DESIGN RECOMMENDATION MEETING - DPD# 3019051

1016 REPUBLICAN HOTEL

06.17.2015

SLU LODGING, LLC

RECOMMENDATION 1C

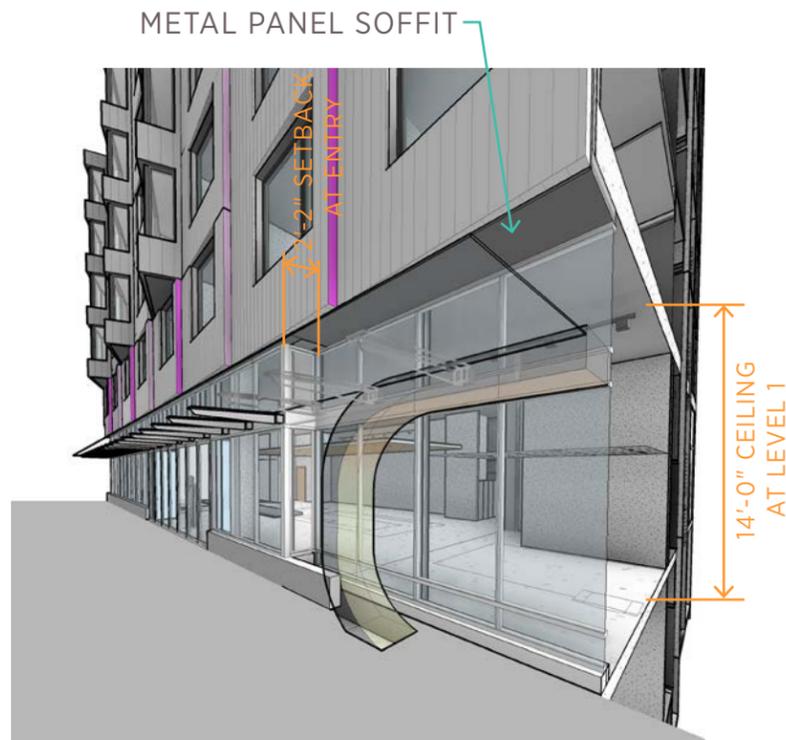
The board strongly urged the applicant to use material detailing and color to convey the particular type of boutique hotel.

An open and glassy ground floor with metal panel cladding on the upper levels indicate the modern-industrial character of the hotel Brand.

Color highlights create a charismatic building identity corresponding to the hotel's branding character. The highlights are integrated subtly into panel returns and window heads.

LED lighting will accentuate the vertical color-highlights at night, differentiating the hotel and restaurant from neighboring office buildings.

RECOMMENDATION 2A

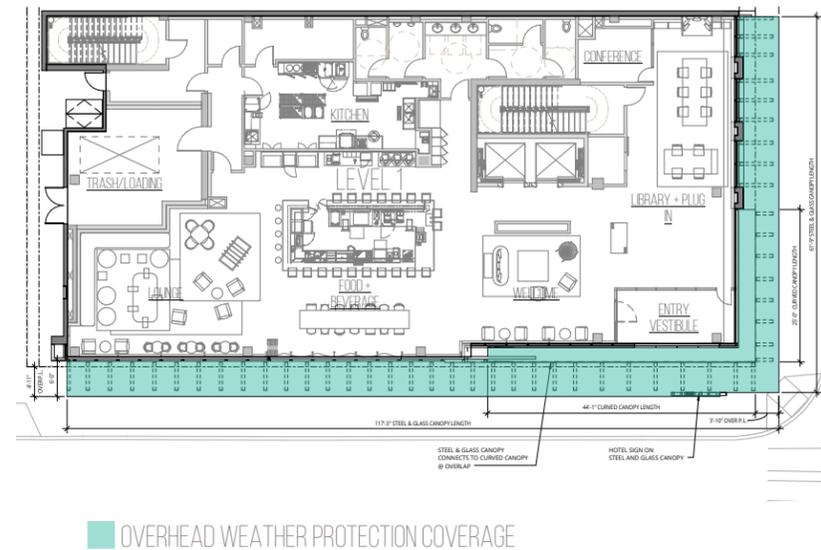
The Board supported the 15' ground floor height and setback and recommend further study of the relationship between the setback and massing above. A setback at the restaurant location could also be studied further to allow for more spillover sidewalk space.

The ground floor height and setback have been maintained. The soffit material above the setback will match the metal wall panels, giving the building the effect of floating above a glass base.

RECOMMENDATION 2B

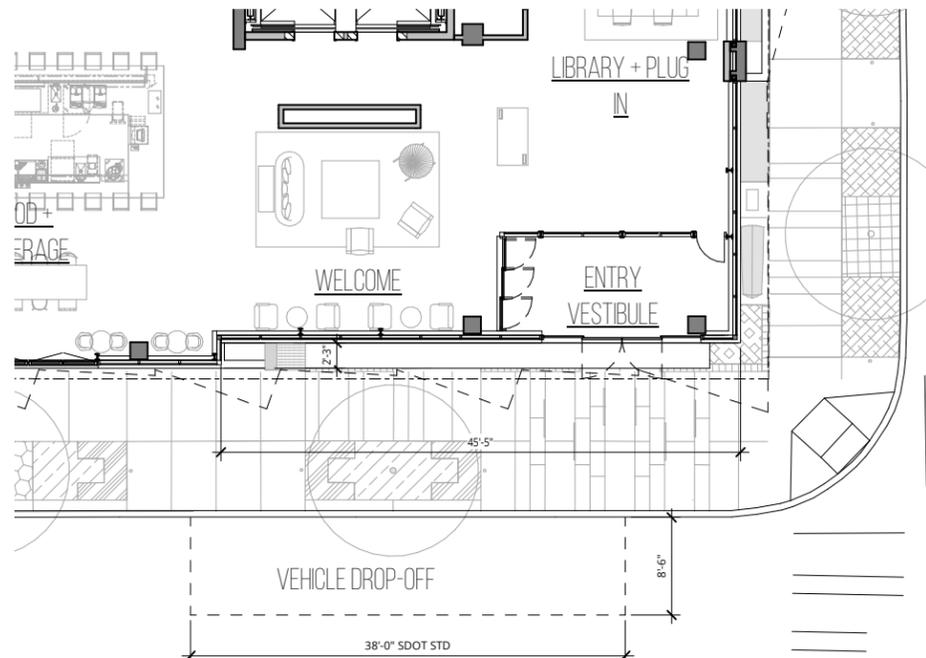
The Board unanimously supported the continuous overhead canopy.

A continuous canopy has been maintained.

RECOMMENDATION 3A

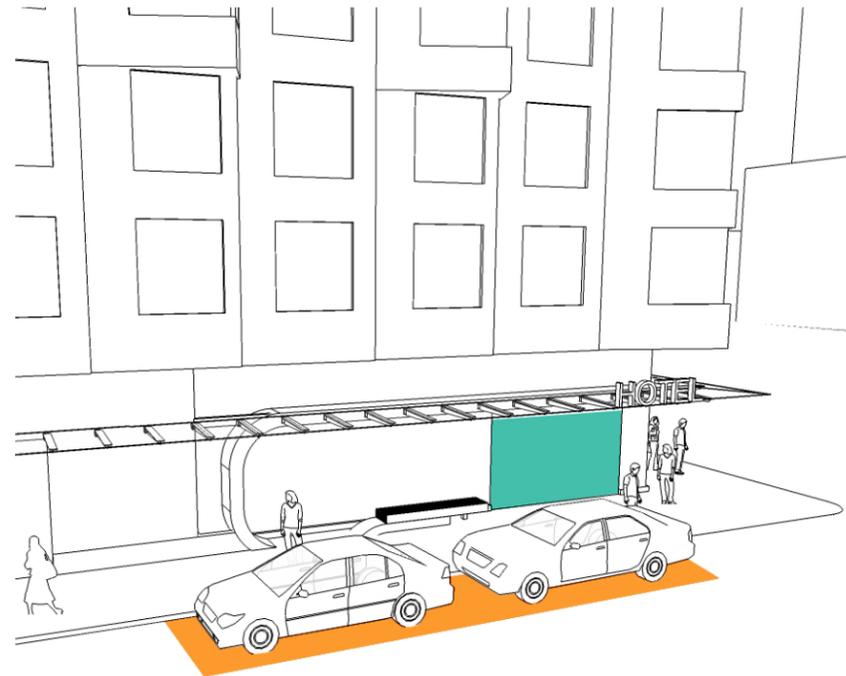
For the hotel, the entry is a node of activity. The Board supported the at grade planting and street furniture near the entry which recognizes this node of activity.

Plantings and street furniture near the entry has been maintained.
